ATTACHMENT 8 APPLICANT'S COMPLETE APPEAL SUBMITTAL, DECEMBER 10, 2012

FILE NO.: AP-12-02 and AP-12-03

Appeals for Lake Oswego – Tigard Water Partnership:

Lake Oswego WTP application (CUP 12-02) and RWP/FWP application (CUP 12-04)

Figure 14A-1. WTP Construction Schedule

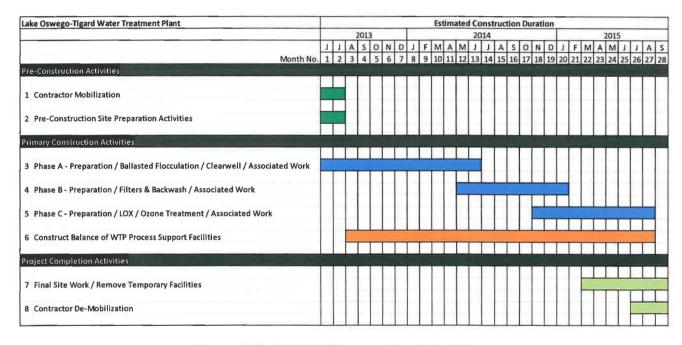
The design team has decreased the overall project construction schedule from 32 months to 28 months. Shortening the duration of the project by four months will result in a slight increase in the volume of daily and hourly construction traffic and related impacts during construction but will significantly decrease the amount of time that residents experience these impacts. Figure 14A-1, WTP Construction Schedule, shown below incorporates the decreased construction duration and replaces the figure by the same name in previous land use application submittals. All project phases remain the same as previous applications submittals, but each project phase duration has been shortened to obtain the cumulative duration decrease of four months.

Stormwater Report, Figure 2.0

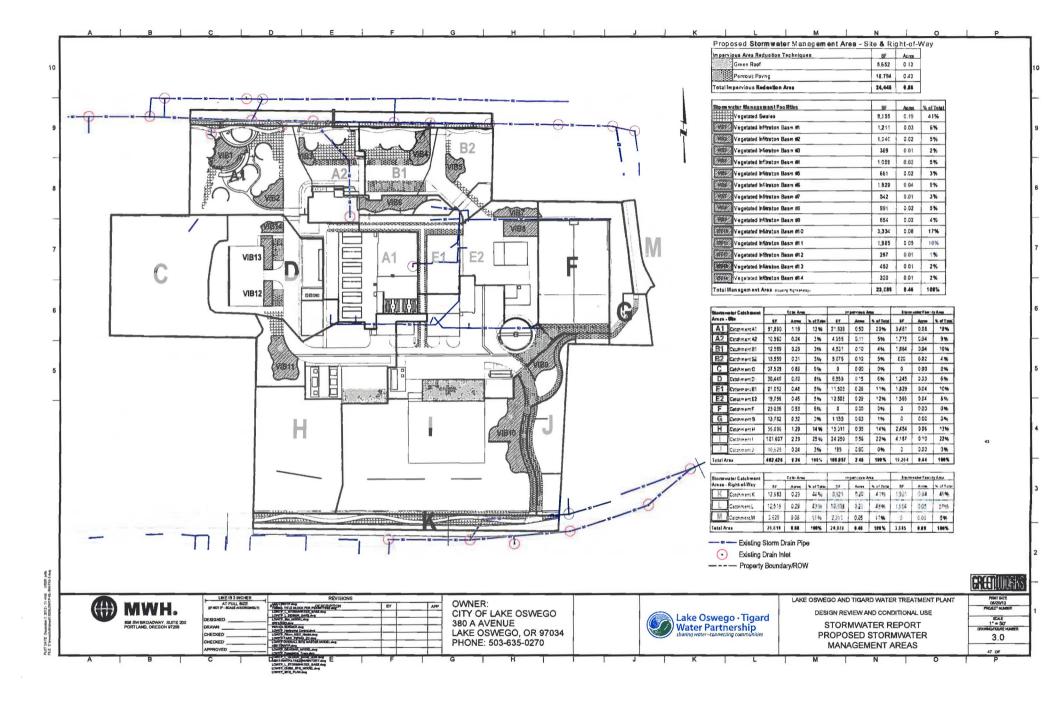
Pervious Surfaces = 7,849 sf (27% of ROW)
 Impervious Surfaces = 20,970 sf (73% of ROW)

See attached Figure 2.0 for more detailed area breakdown

September 27 Update - Figure 1. Combined construction project traffic on Mapleton Drive

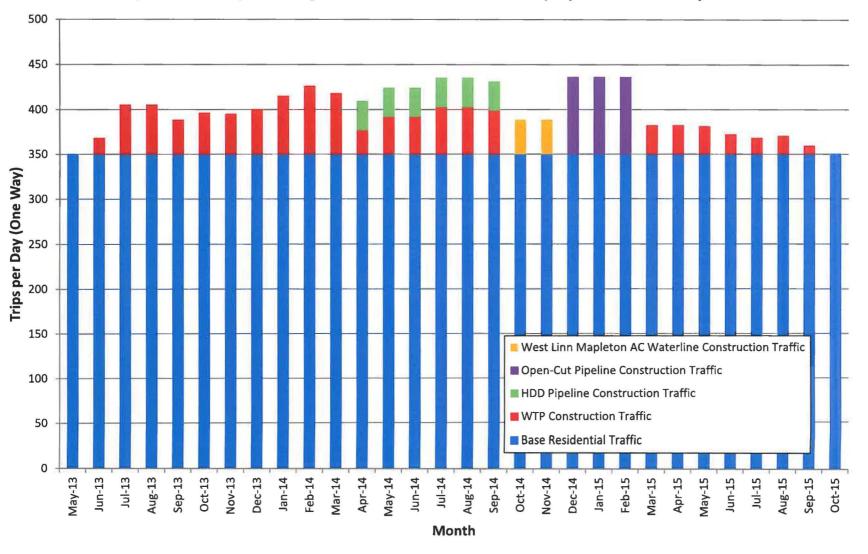
The September 27 land use application memo included combined construction related traffic on Mapleton Drive and Kenthorpe Way resulting from WTP and pipeline construction related activities. Updated Figures 1 and 2 are included in this document and reflect the four month decrease in WTP construction duration. Due to the change in WTP and pipelines construction overlap the maximum one-way construction traffic on Mapleton Drive will remain at 86 trips per day and the maximum one-way construction traffic on Kenthorpe Way will be reduced from 95 trips per day to 91 trips per day.
